HISTORIC AND DESIGN REVIEW COMMISSION

HDRC CASE NO: 2019-040
ADDRESS: 306 KING WILLIAM
LEGAL DESCRIPTION: NCB 743 BLK 2 LOT 12
ZONING: RM-4,HS
CITY COUNCIL DIST.: 1
DISTRICT: King William Historic District
LANDMARK: Giles-Diaz House
APPLICANT: Daniel G. & Sandra Lee Rodriguez
OWNER: Daniel G. & Sandra Lee Rodriguez
TYPE OF WORK: Replacement of metal roof with cedar shakes
APPLICATION RECEIVED: January 18, 2019
60-DAY REVIEW: March 19, 2019
REQUEST:

The applicant is requesting a Certificate of Appropriateness for approval to replace the existing standing seam metal roof with a new cedar shake roof.

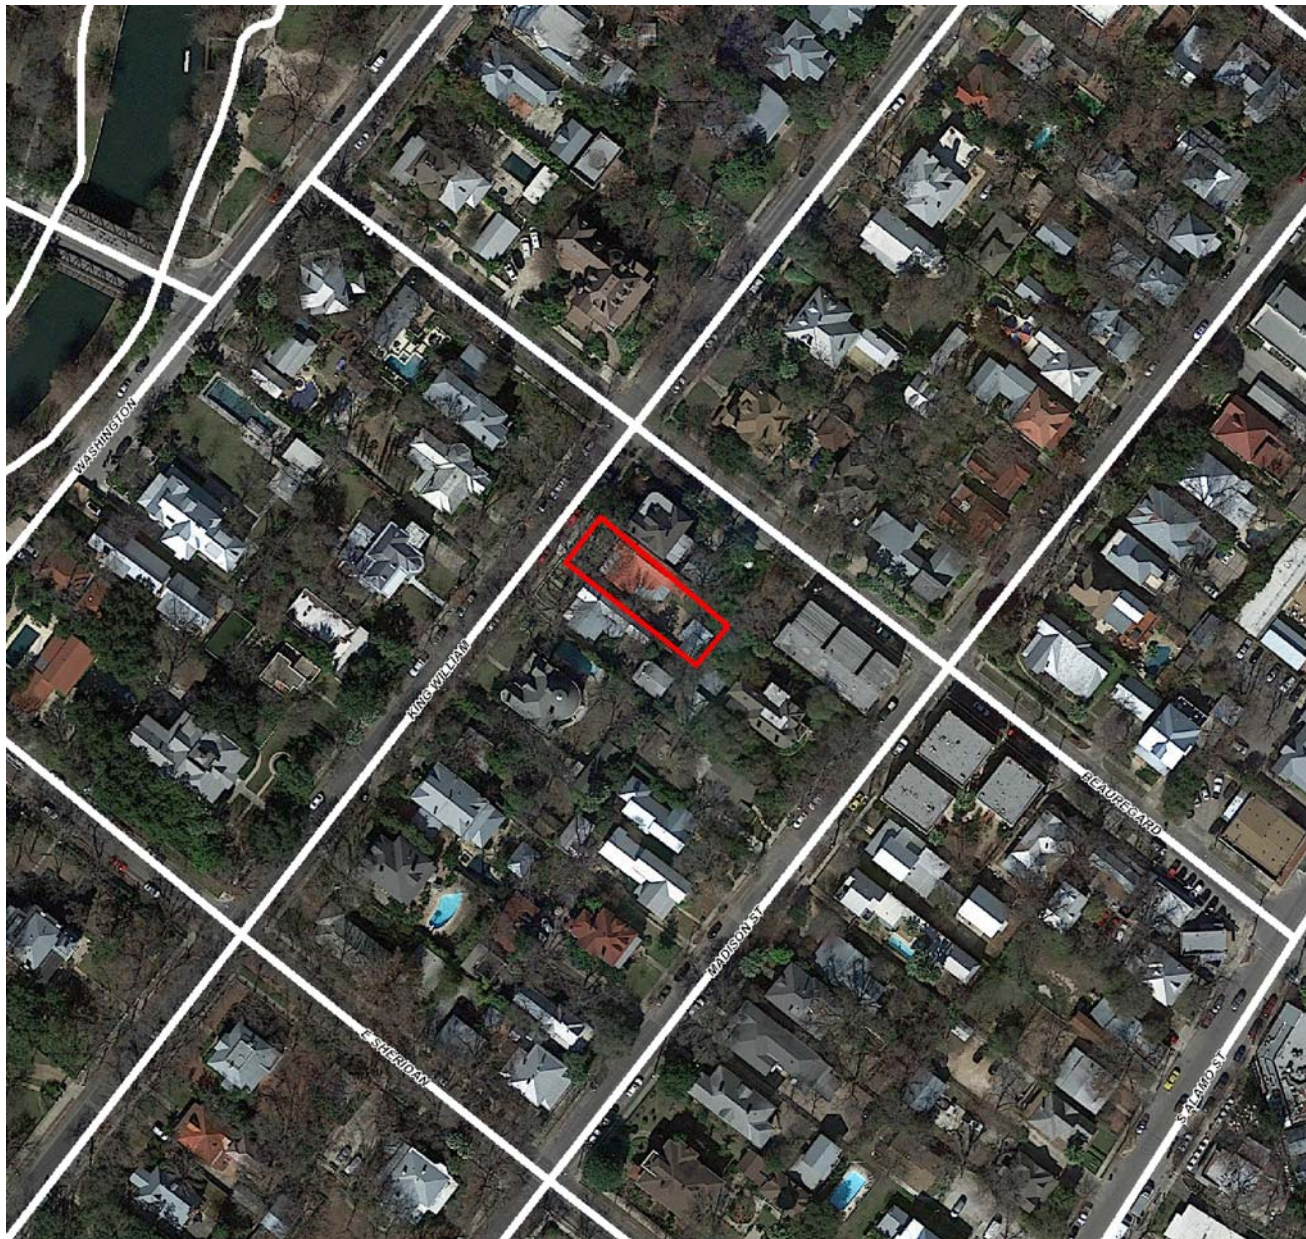
- b. The applicant has requested to replace the existing standing seam metal roof with a new cedar shake roof. According to the Historic Design Guidelines, when roof replacement is required, the roof should be repaired in-kind. According to Sanborn Maps (1904, 1911-1951), this property historically had a metal roof, as did the adjacent twin structure at 308 King William. The roof also appears to be original or has been in place for several decades. Metal roofs in the existing configuration are typical of Folk Victorian-style homes. Staff does not find the proposal to replace the metal roof with shake shingles consistent with the Guidelines.

If replacement is necessary, staff recommends that the applicant install a new standing seam metal roof to match the existing. The roof must feature panels that are 18 to 21 inches wide, seams that are 1 to 2 inches tall, a standard galvalume finish, and a crimped ridge seam. A ridge cap should not be used. The applicant must contact staff 24 hours prior to installation in order to schedule an inspection to verify that metal roof specifications are met. In-kind roof replacement is eligible for administrative approval.
